**BOARD OF COMMISSIONERS OF THE PORT OF NEW ORLEANS**  
**NOTE TO PERSPECTIVE BIDDERS**  
**CONTRACT FOR**  
**HARMONY STREET WHARF**  
**ROOF REPLACEMENT**  
**DAMAGED BY HURRICANE KATRINA**

July 2, 2009

ADDENDUM NO. 1

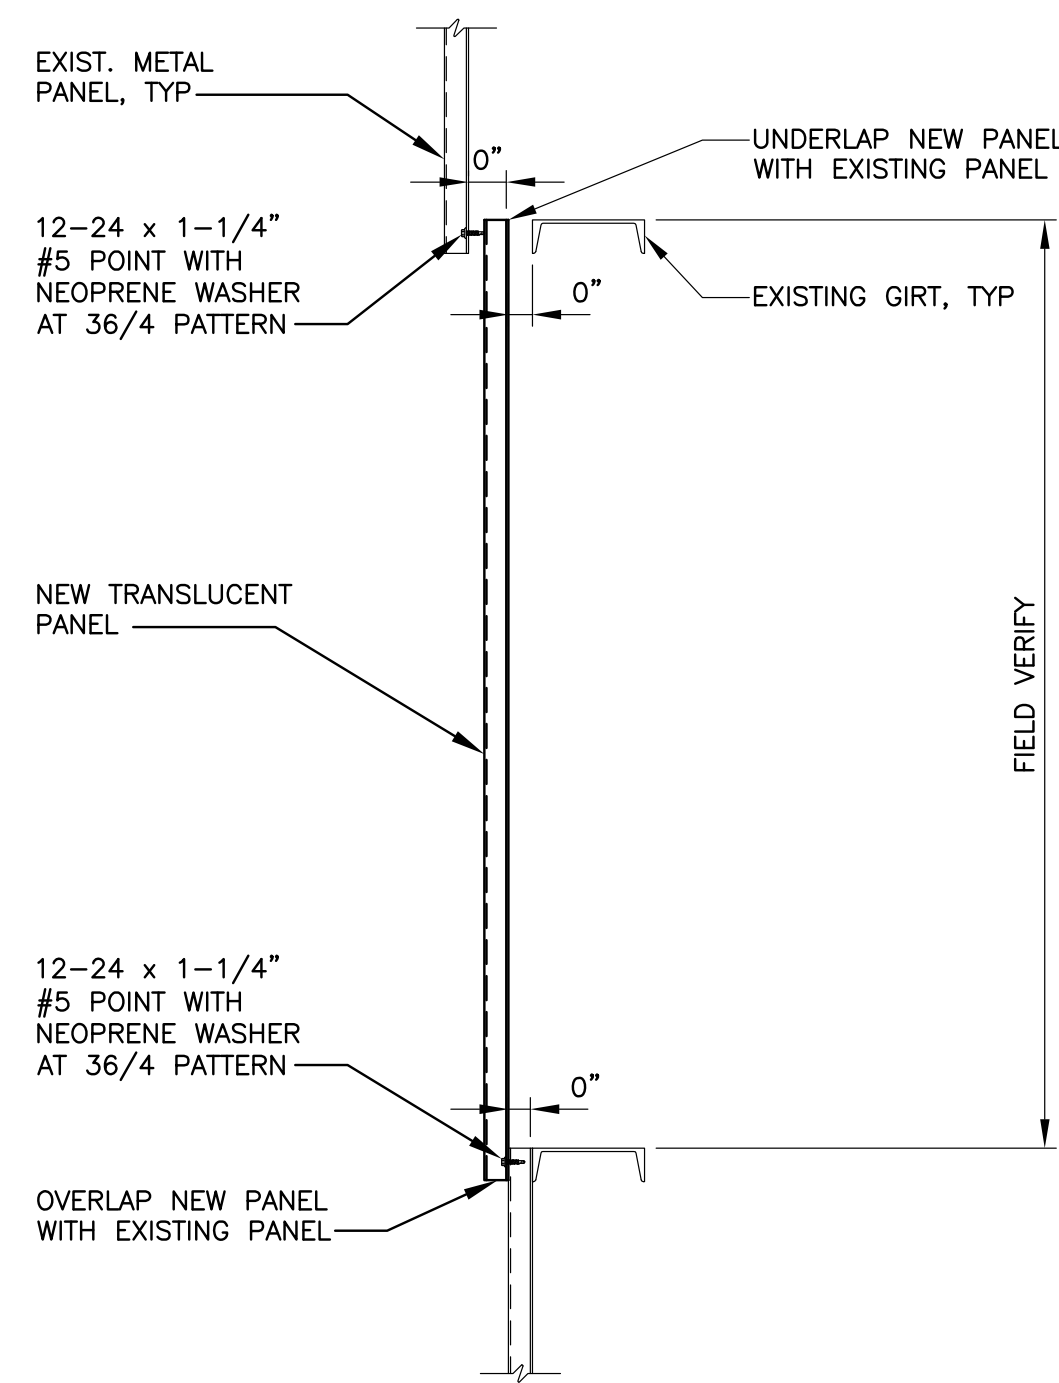
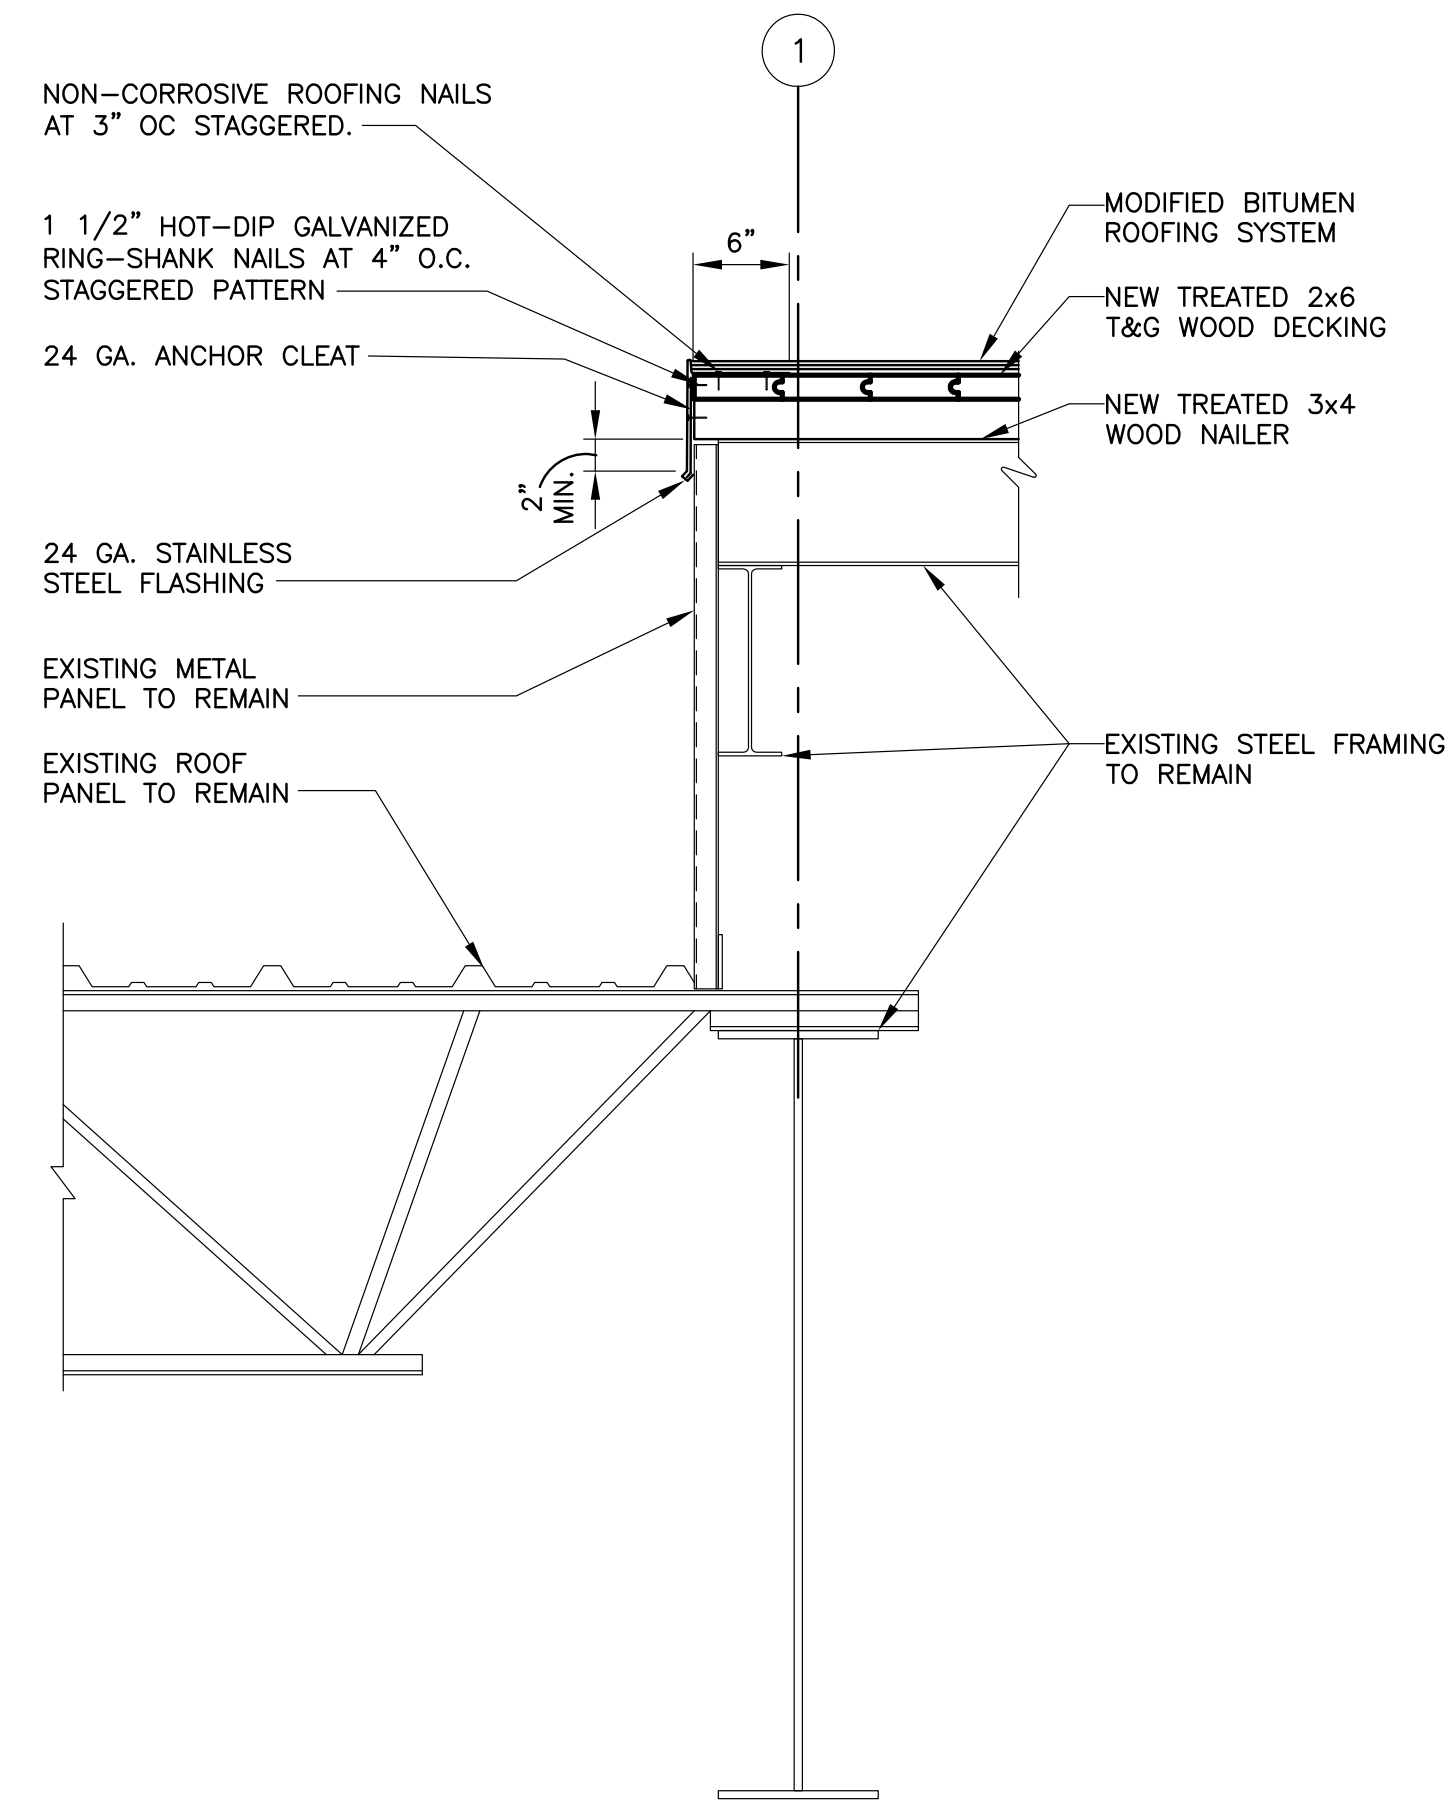
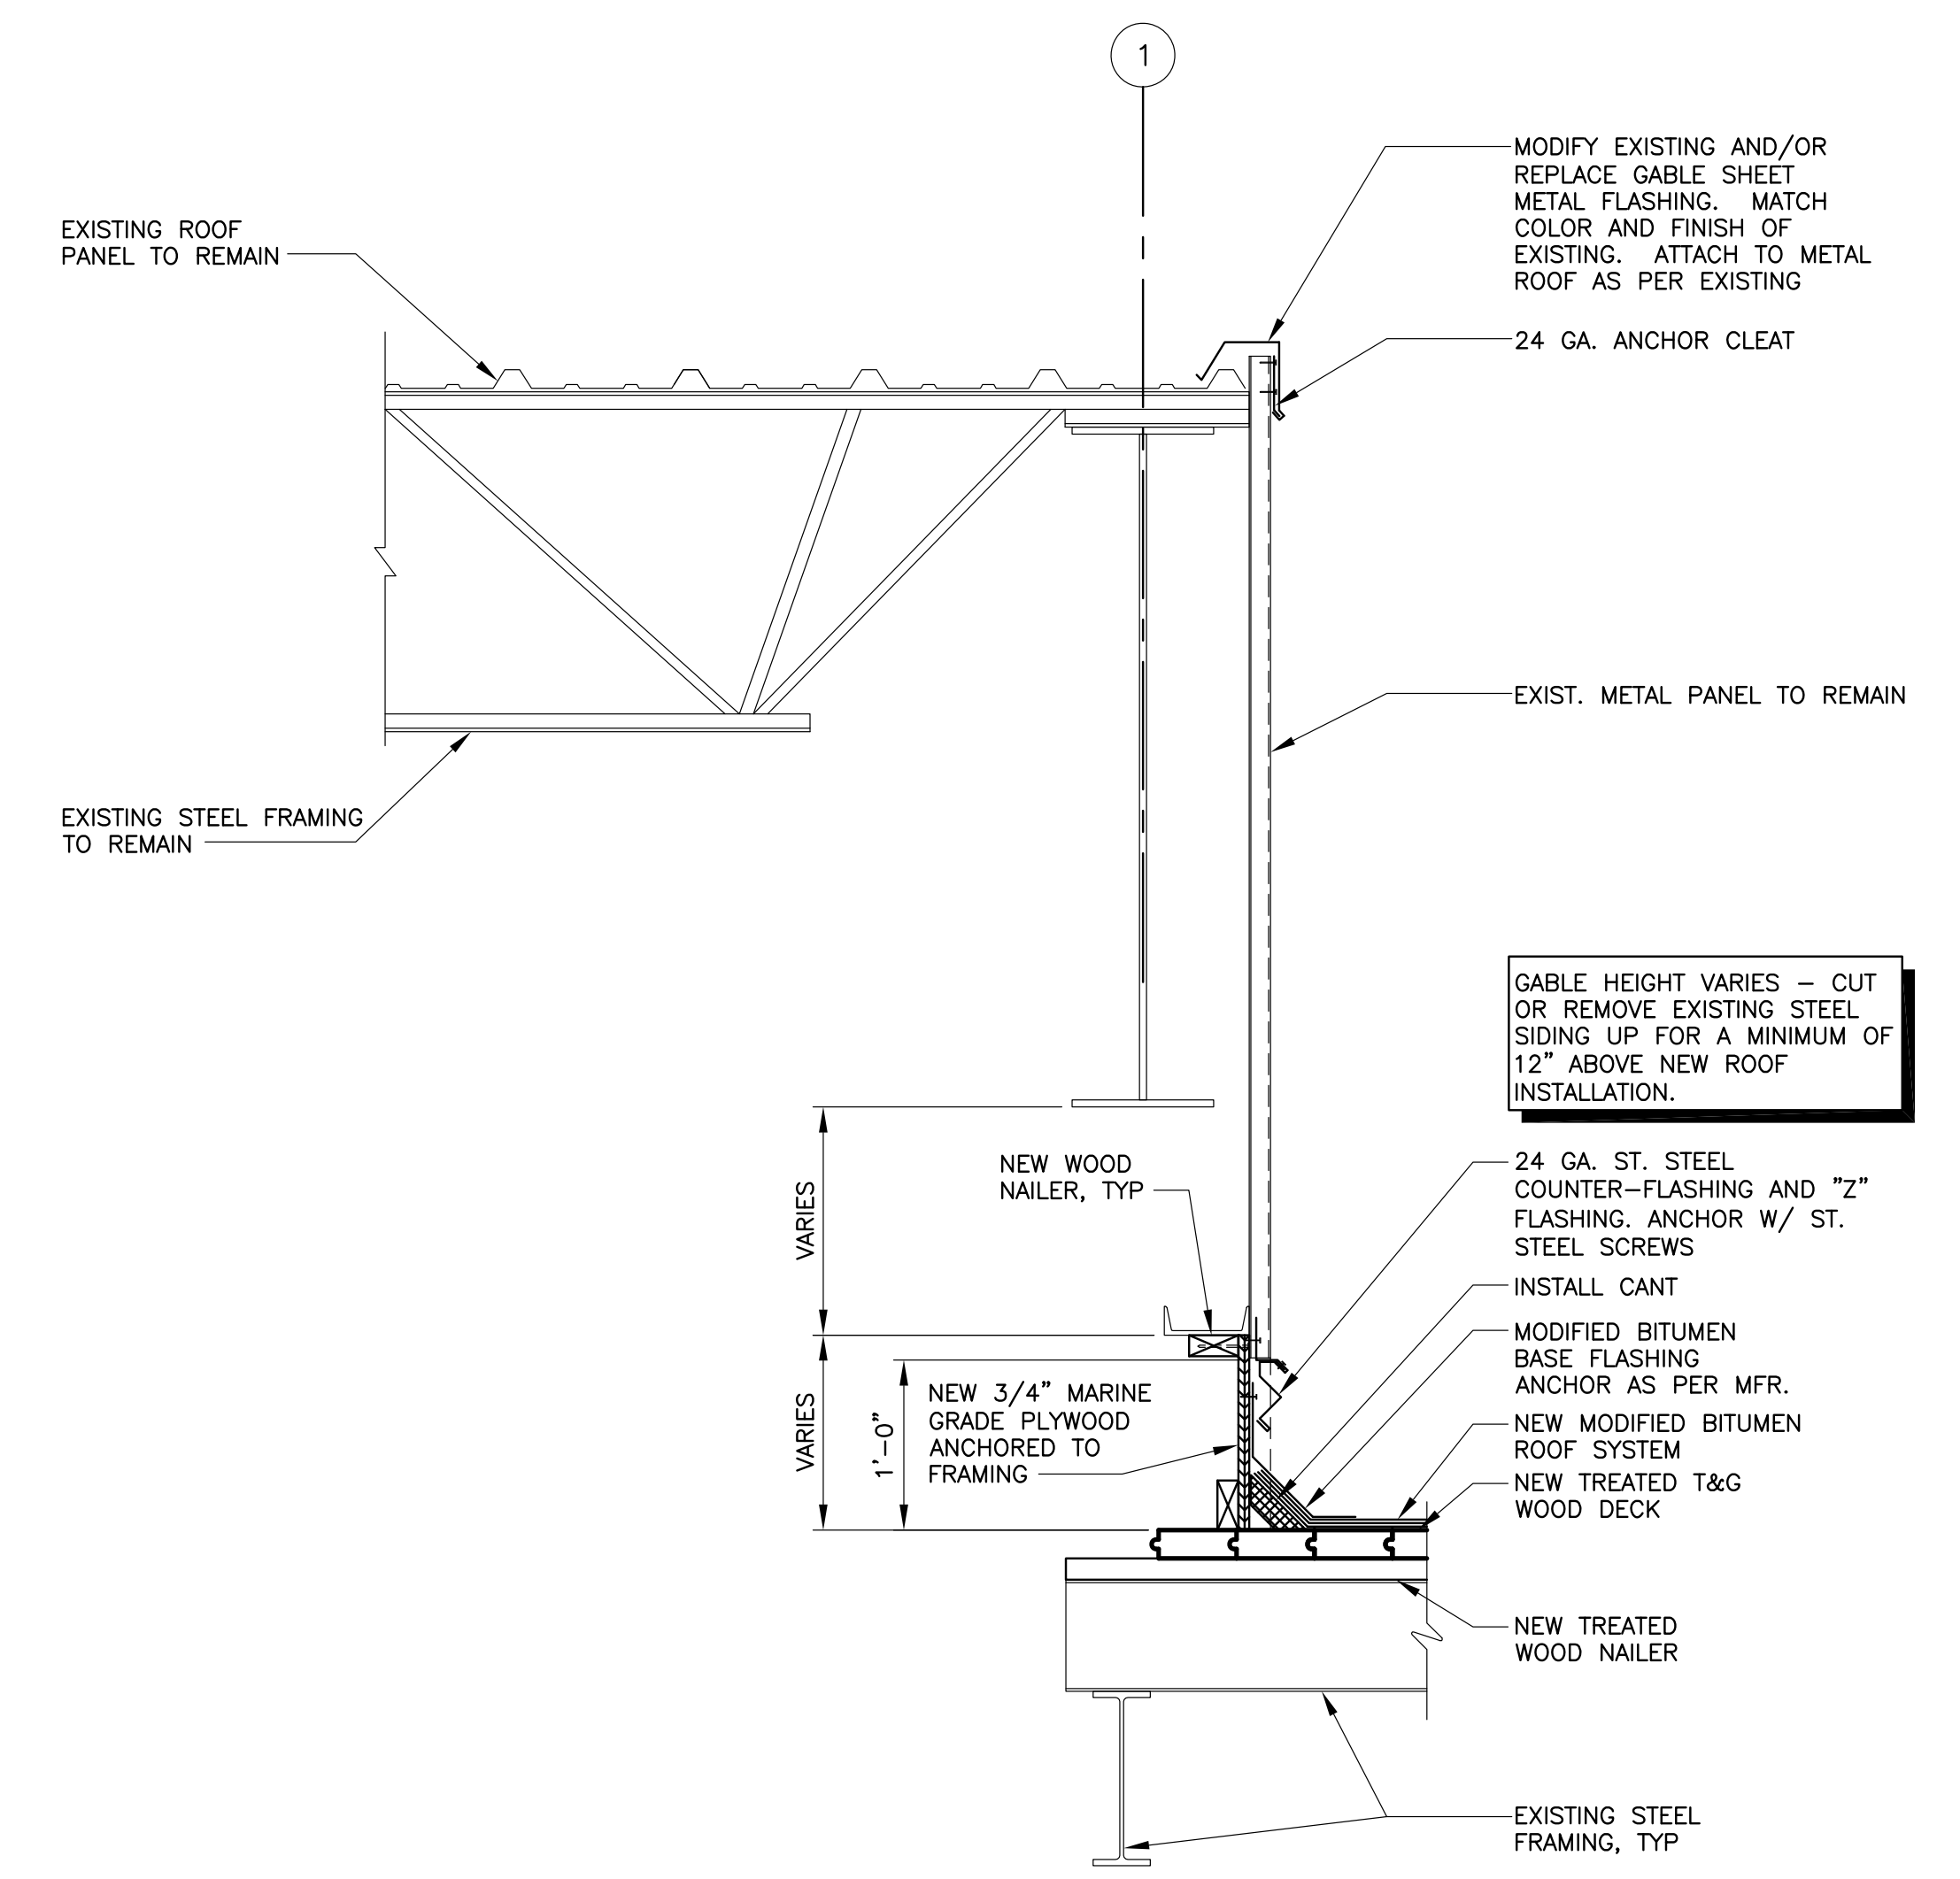
- A: Detail 2 on drawing 7 has been modified to provide reference for cowl dimensions. Revised drawing is part of this addendum.
- Q: Plan # 9 No detail or specs to modify Metal Cladding and is installing 3/4" plywood in our scope of work? Also no where in price schedule.

- A: Drawing 8A has been added to address these issues and is part of this addendum. In addition, a bid item has been added for the plywood.
- Q: Plan # 9, No detail on saddle, is there a detail and/or pictures of this area?

- A: Drawing 8A has been added to address these issues and is part of this addendum.

NOTE: AREAS OF THE ROOF WHERE FLASHING HEIGHTS ARE LESS THAN 8" ON EITHER SIDE OF THE COLUMN LINE No. 1, THE ROOFING ON BOTH SIDES NEEDS TO BE FLASHED WITH CUSTOM FABRICATED 24 GA. ST. STEEL, POP-RIVETED SADDLE WITH ALL JOINTS SOLDERED COMPLETE. FLASHING MUST BE INSTALLED TO SHED WATER FROM HIGH POINT TO LOW POINT. LAPS TO EXTEND 6" MIN. ALL ROOFING, FLASHING ON ASSOCIATED ITEMS MUST BE REMOVED, MODIFIED, OR REPLACED WITH LIKE IN KIND TO ACHIEVE A FULLY FLASHED WATER TIGHT DETAIL.
